2. Markham Estates; KPB File 2025-117

**Edge Survey & Design / Zachary Markham & Erica Markham
Living Trust**

**Location: Frontier Avenue off Kenai Spur Highway
Ridgeway Area**

STAFF REPORT

PRELIMINARY PLAT

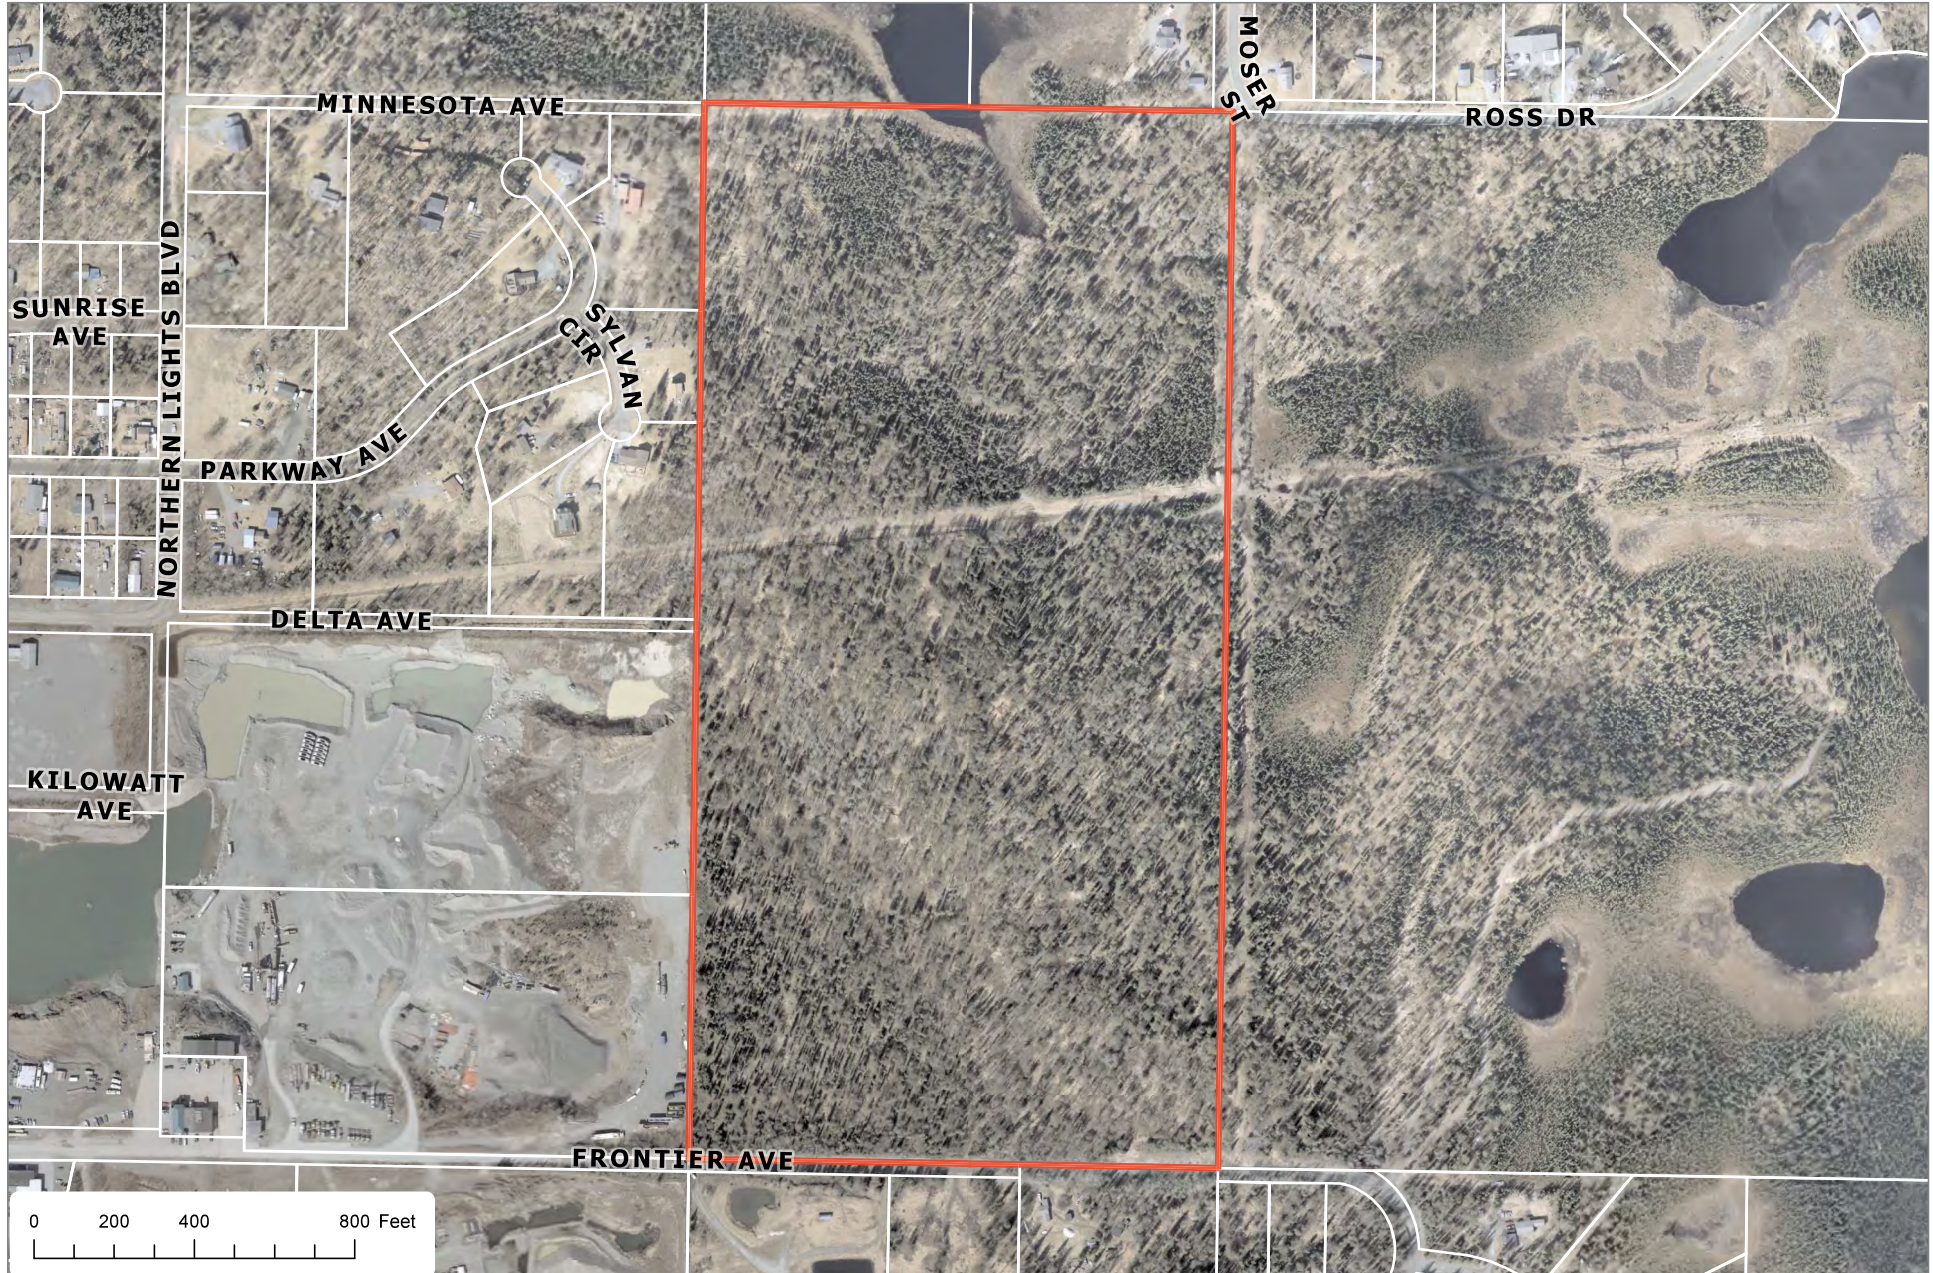
The plat is proposing to dedicate 30' dedications ending in cul-de-sac bulbs on the north extending Minnesota Ave east into the plat and Ross St west into the plat. There is a pond on the north line preventing the road from connecting. **Staff recommends** the surveyor may reduce the length of the neck portion of the roads at theirs and the owner's discretion, but to retain the bulb to standards for emergency vehicle turn around standards. The plat is also proposing to dedicate the north half of Frontier Ave on the south side of the plat. The adjacent portions of Frontier Ave are a mix of dedications and section line easements for some of the undeveloped properties. **Staff recommends** the surveyor modify the drawing to make the dedications stand out, as the section line easement are valid until vacated in all locations shown on the drawing.

The subdivision is affected by a section line easement on the south and east side of the plat. **Staff recommends** the surveyor modify the drawing as noted above to make the section line easement distinct.

SOA ROW Engineering	Title block has wrong property description. This property is the East half not the West half. Please adjust note 4 as this property has 2 Patents: Patent 997 Bk 57 Pg 300 (1970-000208-0) covers the NE4SE4 and Patent 995 Bk 57 Pg 302 (1970-000210-0) covers SE4SE4. Both halves are subject to a 25' pipeline easement per patent.
SOA DOT & PF	No comments

The KWF Wetlands Assessment indicates there are areas of wetland on the property indicated as depression and kettle. **Staff recommends** these areas be shown on the plat for the final plat submittal.

With the indication of wetlands on the plat, **staff recommends** placing a note on the final plat indicating any person developing the property is responsible for obtaining all required local, state, and federal permits, including a U.S. Army Corps of Engineers wetland determination if applicable

The River Center review indicated the plat to be located in a FEMA designated flood hazard area and the notice as shown in KPB 20.30.280.D should be included on the drawing with both FEMA Panels noted and the flood zone. Designation on the drawing will not be needed. The plat was not indicated to be in a habitat protection district.

There is a 30' public access road and utility easement on the north of the property. Staff recommends the document in Bk 57 Pg 300 be added to plat note 4.

There is a 20' R/W electric distribution line easement noted at plat note 6. As described should be within either the proposed dedication or 10' utility easement.

MARKHAM ST ON PRELIM, IS AN EXTENSION OF MOSER ST AND NAME SHOULD BE MAINTAINED. NEW DEDICATIONS ARE ALSO ALIGNED WITH EXISTING STREETS. Comments: No other comments
Code Compliance	Reviewer: Odren, Eric Comments: No comments
LOZMS Review Planner	Reviewer: Raidmae, Ryan There are not any Local Option Zoning District issues with this proposed plat. Prior Existing Use PEU Recognized Date: 1/1/0001 Material Site Comment: There are two PEUs that are adjacent to the subject parcel, PEU1968-002 and PEU1950-001. Their respective PIDs are 057-120-12, 057-120-25 and 057-044-55. PEU1968-002 was recognized on February 27, 2001 and PEU1950-001 was recognized on May 24, 1999.
Assessing Review	Reviewer: Windsor, Heather Comments: No comments

In plat note 4 add both easement book and pages
Adjust the date in plat note 7 to September 8, 2025
Add a Certificate of Acceptance having correct road names.
Plat note 8, second line after treatment, change of to or.

Modify the KPB File No to 2025-117

Change the legal to East ½ of the Southeast ¼

Per the CTP, Assessor Page Info and Authority Documents, the owner's name is 'The Zachary Markham and Erica Markham Living Trust'. Please correct the title block owner name

Verify the owners address, the Assessor's Page has a different address listed.

- C. The location, width, and name of existing or platted streets and public ways, railroad rights-of-way, and other important features such as section lines or political subdivisions or municipal corporation boundaries abutting the subdivision;
Staff recommendation:
On the south, distinguish between the existing road dedications and the section line easements to be more set off.

- ☒ D. A vicinity map, drawn to scale showing location of proposed subdivision, north arrow if different from plat orientation, township and range, section lines, roads, political boundaries, and prominent natural and manmade features, such as shorelines or streams;
Staff recommendation:
Label Moser St north of the plat

- F. The location, width and name of existing and platted streets and public ways, railroad rights-of-way, easements, and travel ways existing and proposed, within the subdivision;
Staff recommendation:
Markham St is an extension of Moser St from the north, name should match Moser St.

- ☐ G. The status of adjacent lands within 100 feet of the proposed subdivision boundary or the land status across from any dedicated rights-of-way that adjoin the propose subdivision boundary, including names of subdivisions, lot lines, block numbers, lot numbers, rights-of-way; or an indication that the adjacent land is not subdivided;
Staff recommendation:
Land to the northwest labeled as unsubdivided is currently in the platting process, surveyor should check prior to final mylar to verify status of plat.
Lot to the southeast needs the plat label corrected.
